SERVICE BULLETIN

APPLICABILITY: 2019MY Forester **NUMBER:** 12-278-20

Combination Meter Visor- Light Leaking

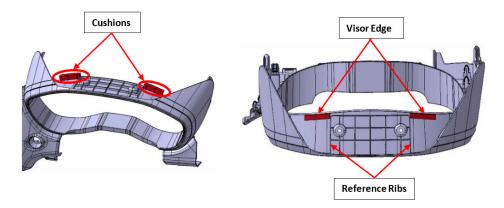
This bulletin provides a procedure to address a limited number of customer concerns regarding light seen "leaking" past the combination meter visor. A small gap can develop between the instrument panel (IP) and the combination meter visor as a result of slight dimensional differences in these parts. When the gap occurs, light may be seen leaking through the gap as shown here.

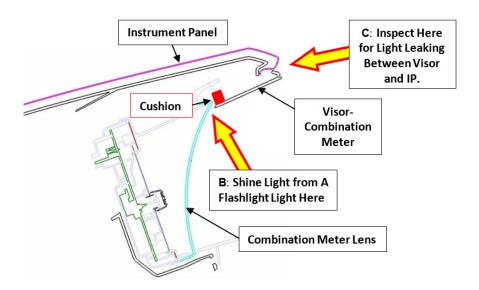
- Remove the combination meter visor following the procedure in the applicable Service Manual.
- Using the illustrations below as a guide, thoroughly clean any dust / dirt from the areas of the visor where the new cushions will be applied.

Two (2) pieces of self-adhesive black foam tape, 5/16" X 3/8" X 1.5" long will be required to make the cushions as described in the Service Procedure below. The foam tape is readily available at home improvement and online retailers.

- Peel the backing from the cushions and apply to the visor as shown in the illustration above.
- Reinstall the combination meter visor in reverse order of removal.
- Using a small flashlight and the illustration below, confirm the repair before reconnecting the battery and resetting the customer's audio system presets (and navigation favorites).
